## PRODUCT CHANGE NOTIFICATION (PCN)

### DK-1511-010/BL MODULAR CABLE

CHANGE NOTIFICATION:	PCN 20220425_DK-1511-010/BL
DESCRIPTION OF CHANGES:	CHANGE OF DATA SHEET CHANGE OF DATA SHEET New Draw.-No. ASS_7160_CAreV04
REASON FOR CHANGE:	CHANGE OF PRODUCT LOCATION CHANGE OF PRODUCT LOCATION
KEY CHARACTERISTICS OF CHANGE:	Details see page 3
PRODUCTS AFFECTED:	DK-1511-010/BL
DATE OF CHANGE AND IMPLEMENTATION:	CHANGE: WEEK 18 / YEAR 2022 IMPLEMENTATION: 25/4/2022
RESPONSE:	NO RESPONSE TO THIS NOTIFICATION IS REQUIRED

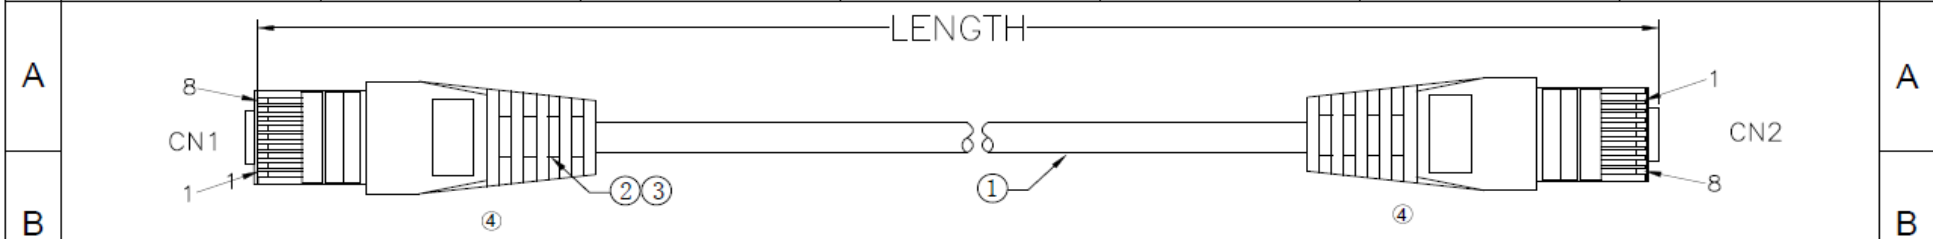
④		2	Molding PVC 65P	④		2	RJ45 8P8C, contacts 3u" gold-plated Un-shielded PC UL94V-2	④		1	CAT 5E U/UTP(24AWGx1PR)*4+PVC Jacket OD:5.2±0.3mm	NO.	NAME	Q'TY	SPECIFICATION
④		2	Molding PVC 65P																
④		2	RJ45 8P8C, contacts 3u" gold-plated Un-shielded PC UL94V-2																
④		1	CAT 5E U/UTP(24AWGx1PR)*4+PVC Jacket OD:5.2±0.3mm																
NO.	NAME	Q'TY	SPECIFICATION																
<p>FOR DETAIL, PLEASE TAKE ATTACHED NEW DRAWING: FOR REFERENCE</p>

Drawing-No. **ASS 7160 CA** rev04

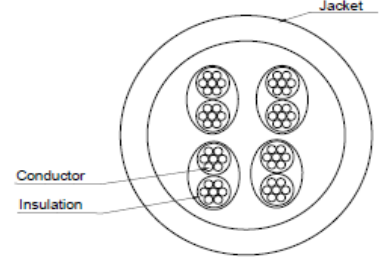
Scale	Free					Date	Name	Customer-No.
TOLERANCE		④	Change the plant	12.04.2022	Luca	Drawn	24.06.2014	Joanna
X.	±X	③	Add tolerance for cable length	20.09.2019	Amy	Approved	12.04.2022	Luca
X.XX		②	Add new length version	06.04.2017	Amy			
X.XX		①	Update length version	07.12.2016	Amy			
DIM	TOL	①	Update length version	07.12.2016	Amy			
X.°		①	Drawn	24.06.2014	Joanna			
Angle	TOL	Id.	Modification	Date	Name
